MM-2001 PINSETTER

Fenix Service Bulletin Number MM-001

Fenix Service Bulletin Number MM-003

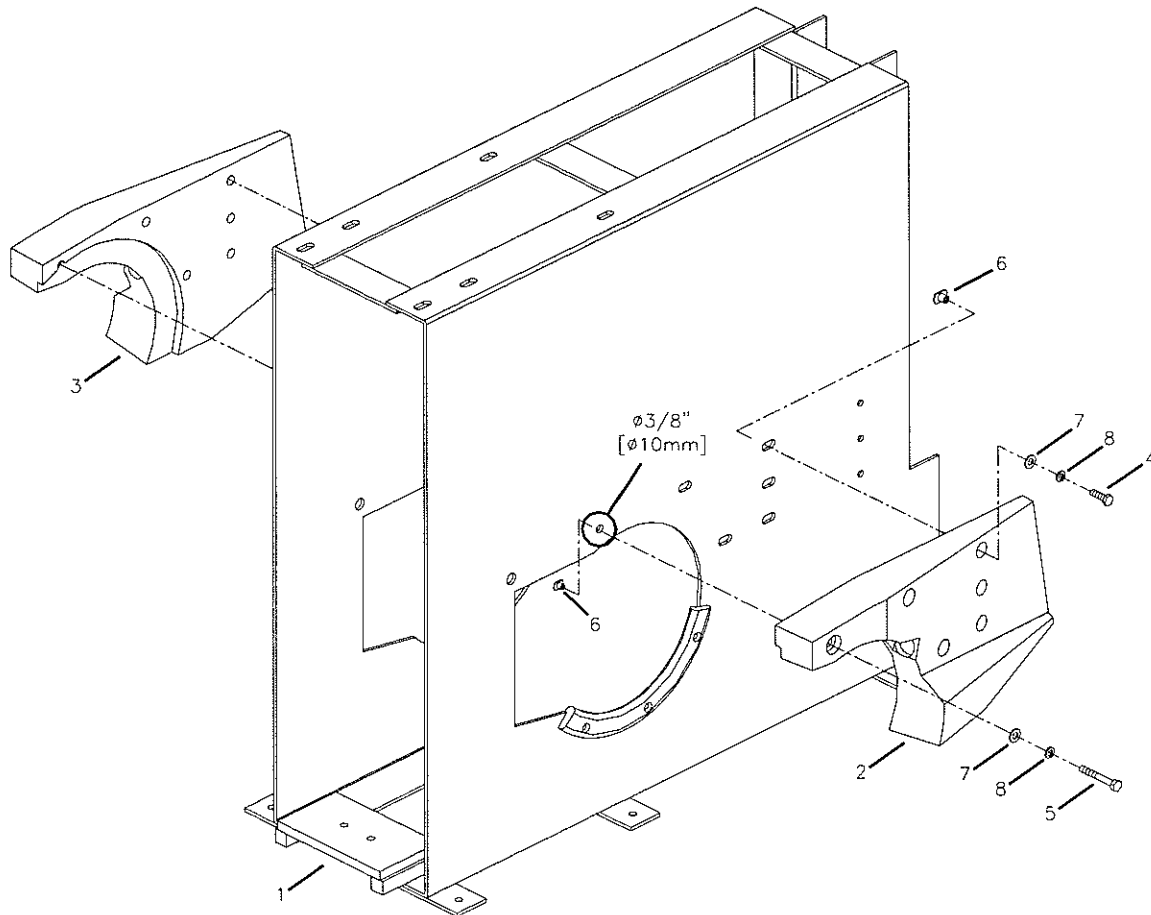
**Modification of the pit deflector blocks***December 1995 (revised March 1997)*

The pit deflector blocks are now produced with an extra hole in order to accommodate for an extra bolt. When replacing old deflector blocks with the newer model, you will have to drill a 3/8" [10mm] hole in the metal kickback in order to accommodate for the extra 5/16" bolt.

The extra hole has been added to the deflector block in order to reinforce its strength and resistance to the constant abuse which it is subject to through the impact of bowling balls.

When replacing old deflector blocks with the newer model, remove the old deflector block and then drill a 3/8" [10mm] hole in the metal kickback as shown in the diagram. Install the new deflector block, making sure that all bolts used to hold it in place are treated with a removable thread locker¹, such as Loctite 242.

Fenix Service Bulletin Number MM-004

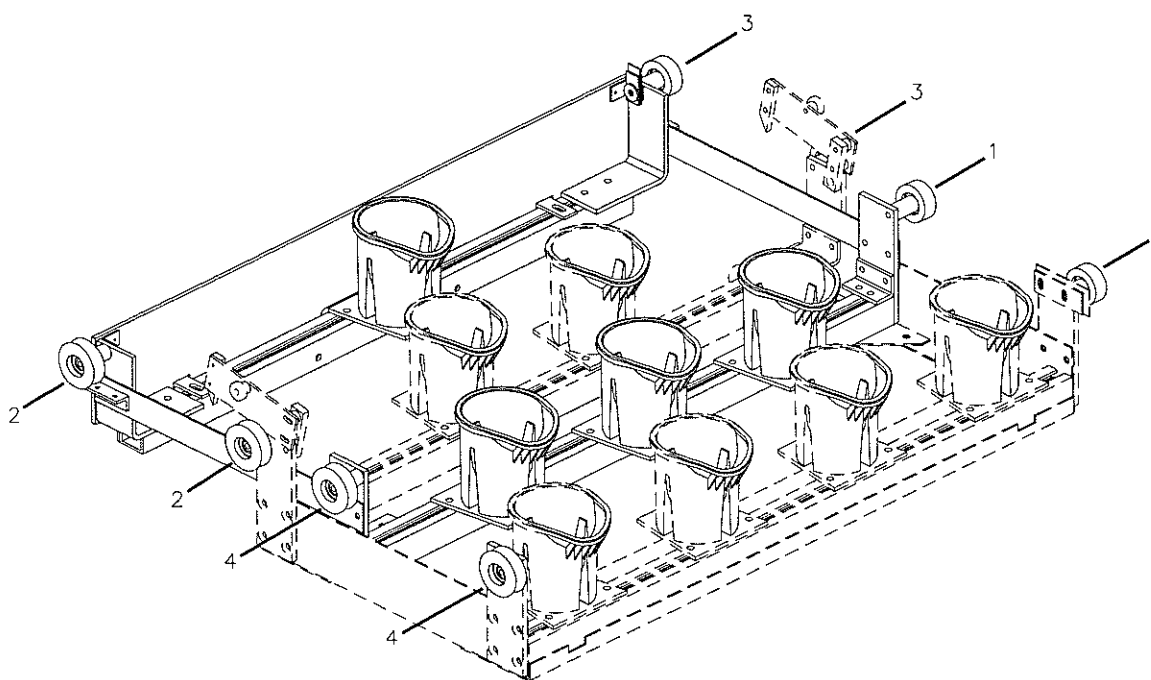
**Modification of the drawer guide rollers***March 1996 (revised March 1997)*

The two rear plastic guide rollers (303-3300-00) have been replaced by aluminum (308-3300-00) ones.

The two rear plastic guide rollers used on the right side of the drawer have a tendency to break due to the impact caused by the pins when the magazine loads the drawer's row of seven.

When replacing plastic guide rollers which support the row of seven on the right side of the drawer, use the new aluminum guide rollers. The plastic guide rollers are now only to be used for the drawer's row of three as shown in the diagram¹.

Fenix Service Bulletin Number MM-009

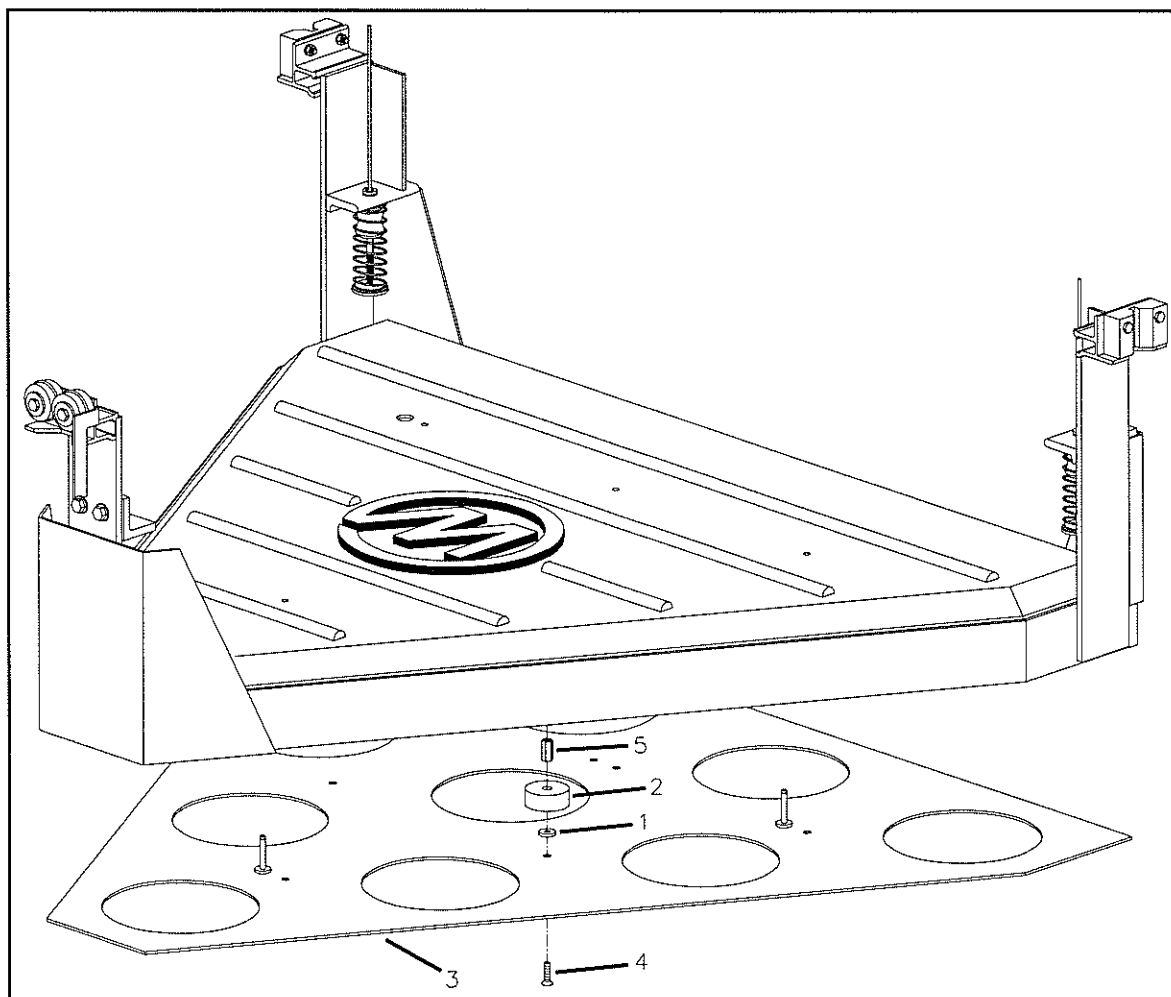
**Removal of the deck detection plate foams***January 1997 (revised March 1997)*

The detection plate foams are no longer installed on new productions of the pinsetter. These foams were initially installed in order to reduce vibration, which could possibly activate the out-of-range input signal. In some cases these foams actually cause false "out-of-range and deck troubles". If you are plagued with inexplicable "out-of-range and deck troubles", the elimination of the deck plate foams will resolve this problem.

These foams have a tendency to absorb the liquid used in the dishes as the liquid splashes around inside. Once the detection plate foams become saturated with the dish liquid, they become highly conductive. This conductivity closes the out-of-range circuit and signals false "out-of-range and deck troubles" on the Magnet 2001 Controller.

In both of the above instances, use the Magnet 2001 Controller to verify the input signal generated from the out-of-range detector at the time of the displayed trouble.

- A) If the out-of-range input signal's value is "0", the trouble message is correct and you should refer to the troubleshooting section of your service manual.
- B) If the out-of-range input signal's value is "1", the out-of-range circuit has caused the problem. To rectify the situation, dismantle the out-of-range plate and remove the detection plate foams along with their accompanying hardware [coupling, washer, and machine screw]. Do not replace the detection plate foams since the distance between the out-of-range plate and the detection unit is large enough to compensate for the minimal vibration.

Fenix Service Bulletin Number MM-010

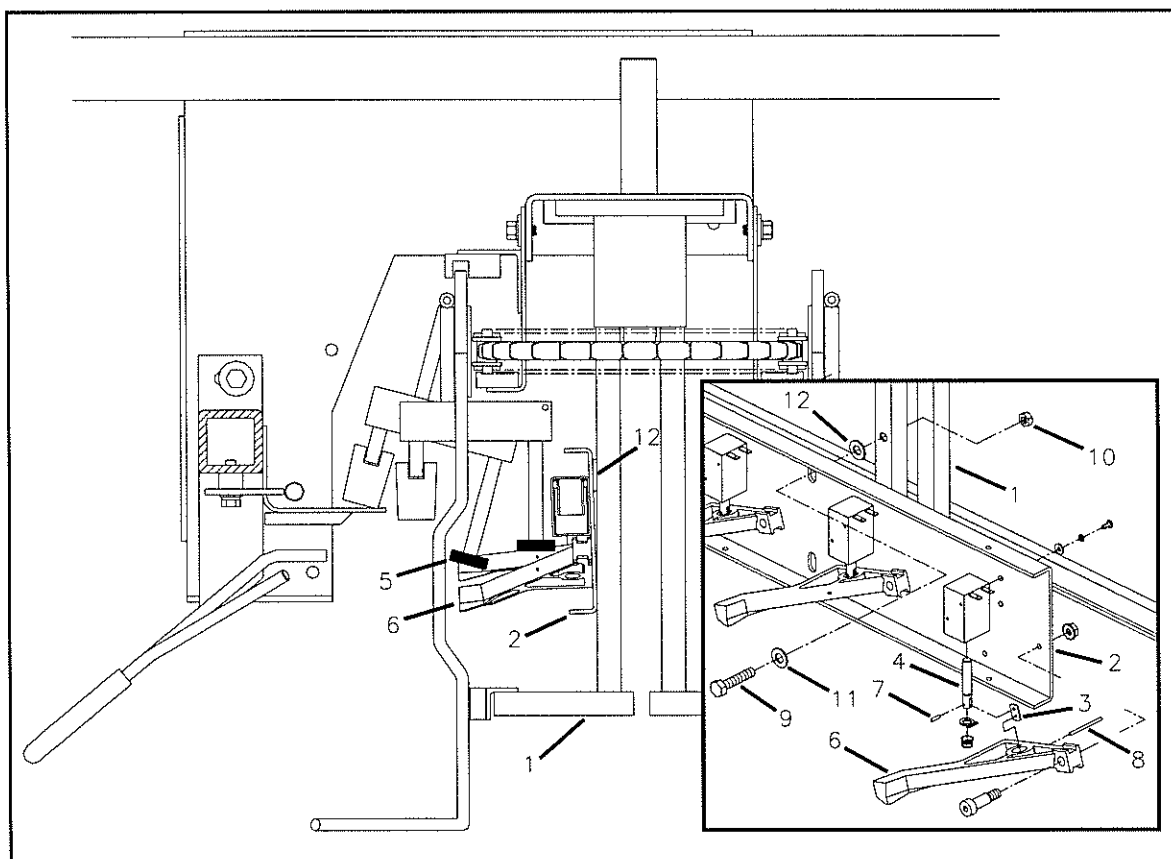
**Adjusting the carousel solenoids***January 1997 (revised March 1997)*

After having performed the above, numerous "sole. (?) carrou troubles" may still occur if the carousel bucket's ball bearings are passing underneath the solenoid cams at the end of their run causing the pin to dump incorrectly.

- 1) Replace the attachment plate used to join the solenoid shaft and the carousel cam.
- 2) Insert 1/8" spacer washers between the center carousel frame and the mounting plate in order to incline the mounting plate toward the ball bearings¹.

¹ Perform adjustment 6E once again after having performed this procedure.

Fenix Service Bulletin Number MM-011

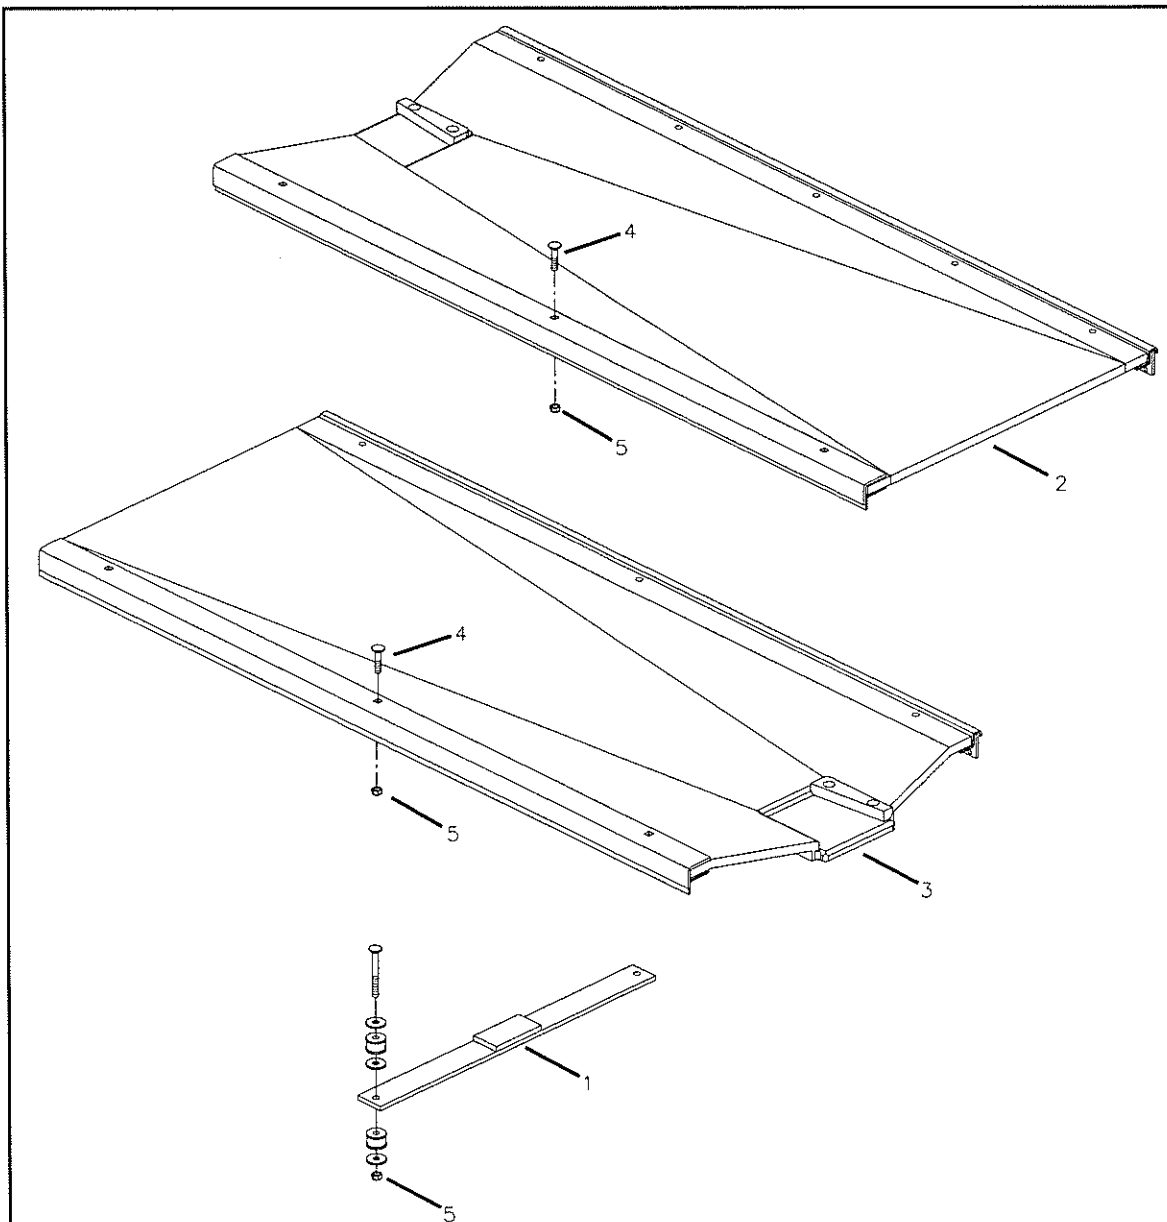
**Modification of the pit table***March 1997*

The pit table center supports are no longer installed on new productions of the pinsetter. These supports were initially installed in order to better support the pit table on its frame. Due to a high breakage level of the bolts used to fasten the support to the table, these center supports have been eliminated.

The constant impact and the violent shocks caused by the bowling ball falling on the pit table eventually breaks the bolts used to fasten the center supports.

If you have broken bolts at this location, remove the pit table center supports and corresponding hardware. Replace the 2-1/2" carriage bolt you removed with a 1-1/2" one. Fasten the bolt in place using the existing nylon nut.

Fenix Service Bulletin Number MM-012

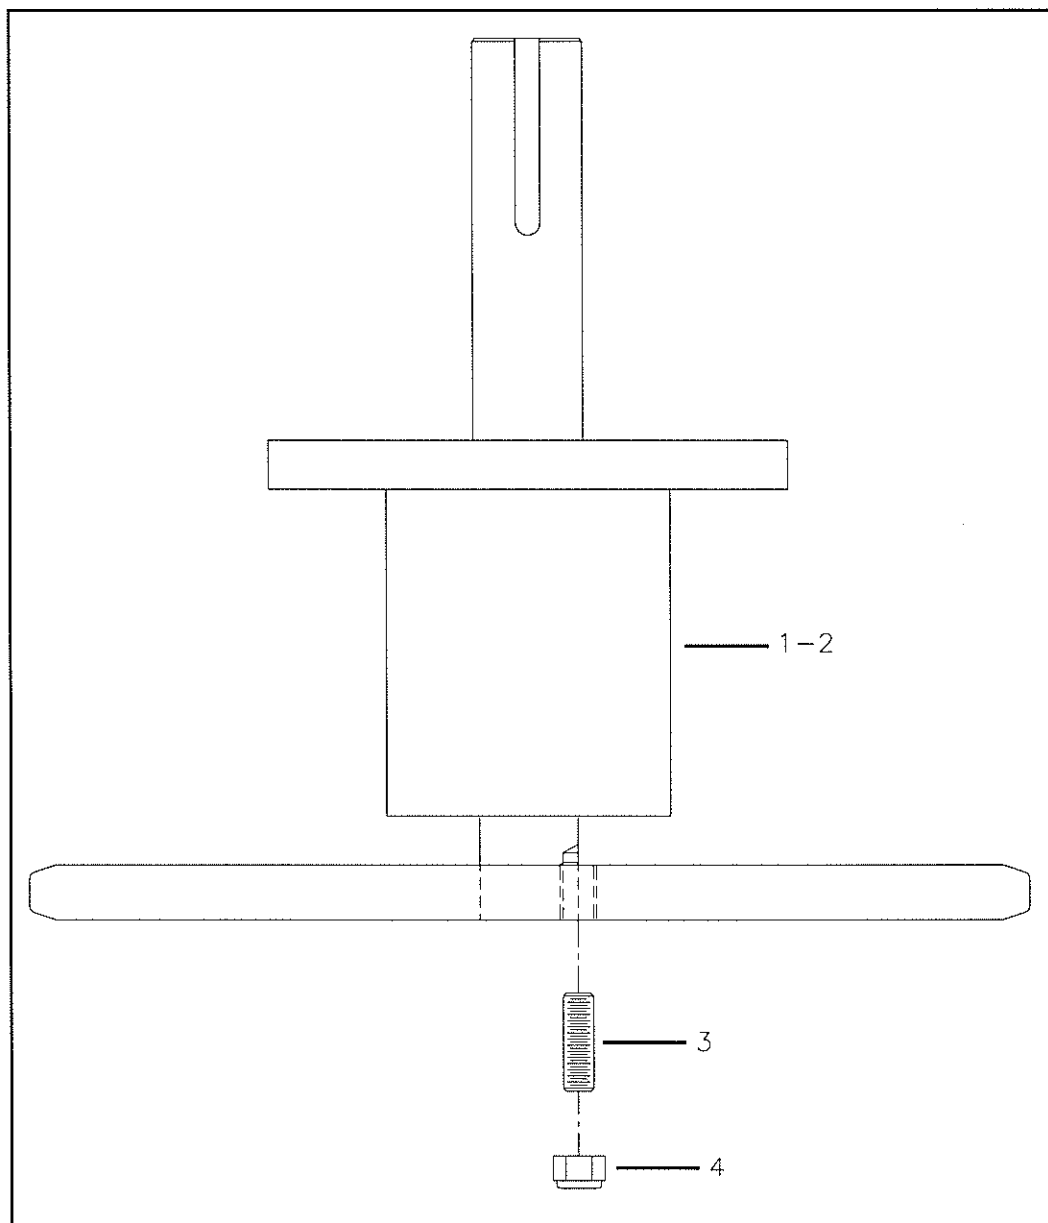
**Modification of the carrousel sprockets***March 1997*

Starting with MM-2001 pinsetter serial number MMP-00787, the carrousel sprockets have been modified from their original design in order to rectify the small problem caused by the set screws becoming loose. The complete sprocket assemblies retain the same number since they remain compatible with the older models. It must be noted that some of the individual parts which make up the complete assemblies have changed. The new carrousel sprockets parts listings will be in the third edition of the MM-2001 Pinsetter Service Manual.

If you have the older model sprockets, simply verify that the set screws are still solidly engaged in place. Remove any loose set screws and replace them with longer ones as shown on the flip side of this bulletin. Make sure that all set screws replaced are treated with a removable thread locker¹, such as Loctite 242. Lock the new set screw in place using a nylon nut.

Fenix Service Bulletin Number MM-013

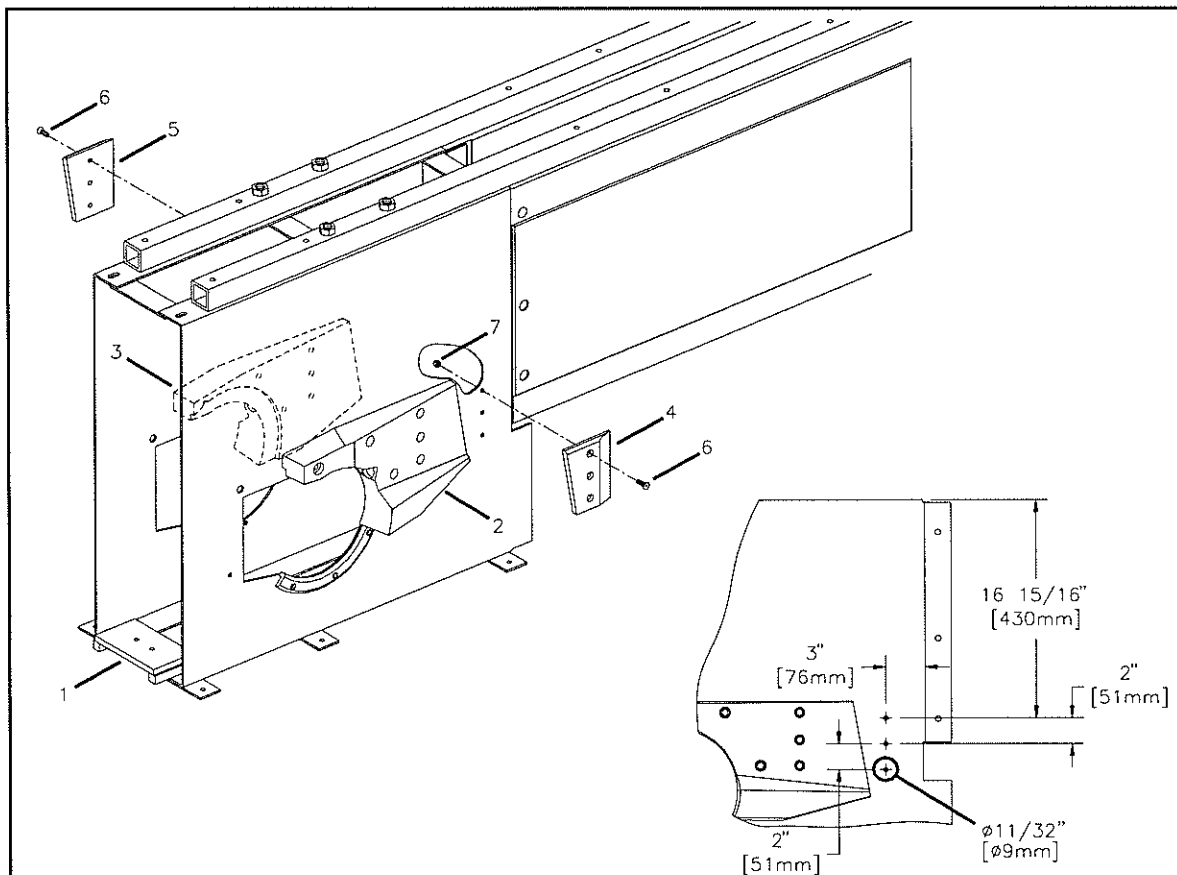
**Addition of the ball deviators***March 1997*

Starting with MM-2001 pinsetter serial number MMP-00717, ball deviators have been added to the front of the pit deflector blocks.

**Modification of the carousel O-ring guard***March 1997*

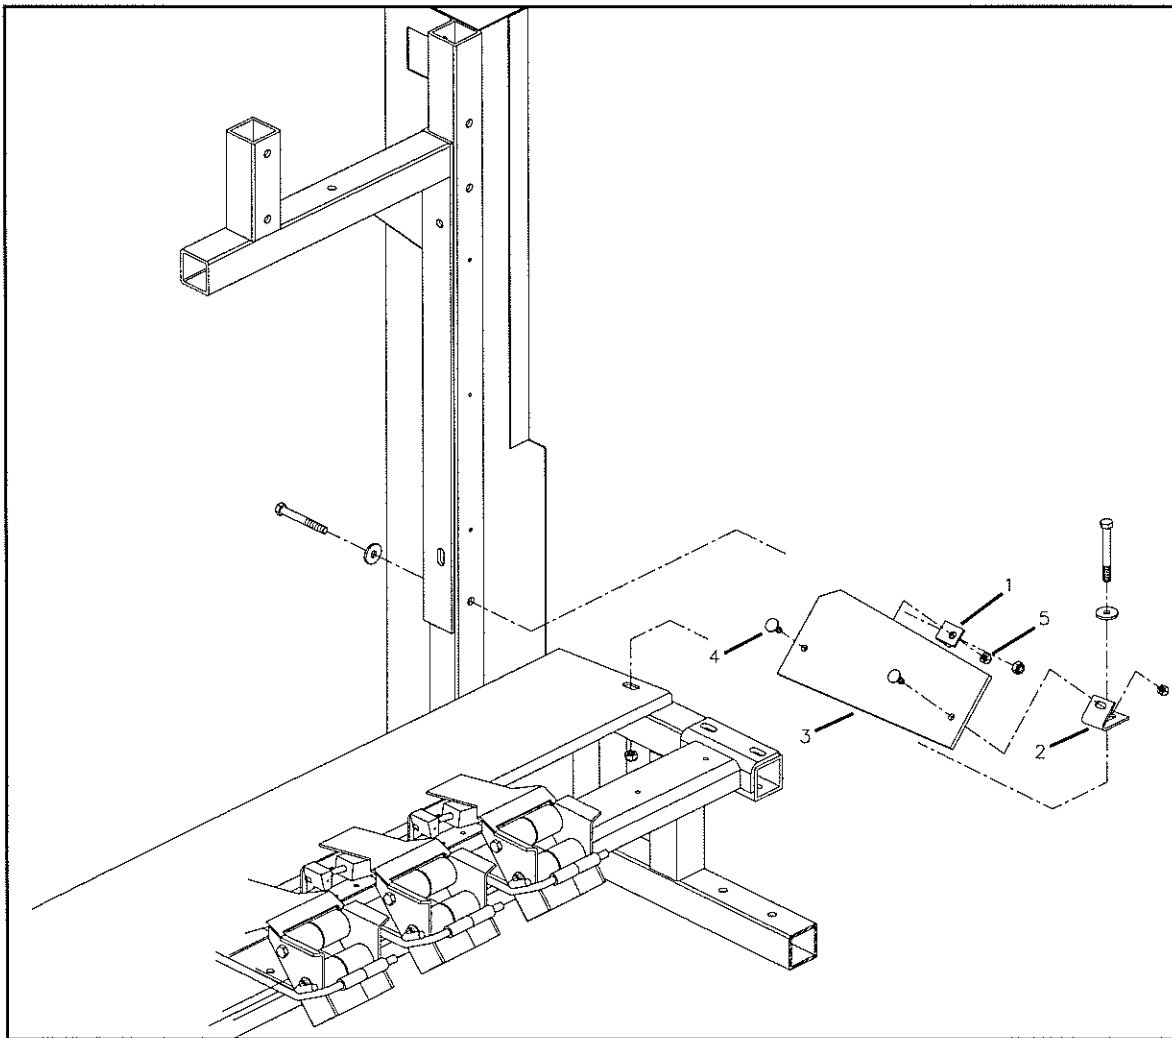
Starting with MM-2001 pinsetter serial number MMP-00779, the carousel O-ring guards have been modified. Although its design has changed drastically, the newer model is 100% compatible with the older pinsetters.

This measure was proven necessary in order to reduce the number of pins which were falling onto the drawer slides causing "drawer troubles".

If you experience this problem, simply replace the older model O-ring guard with the new one.
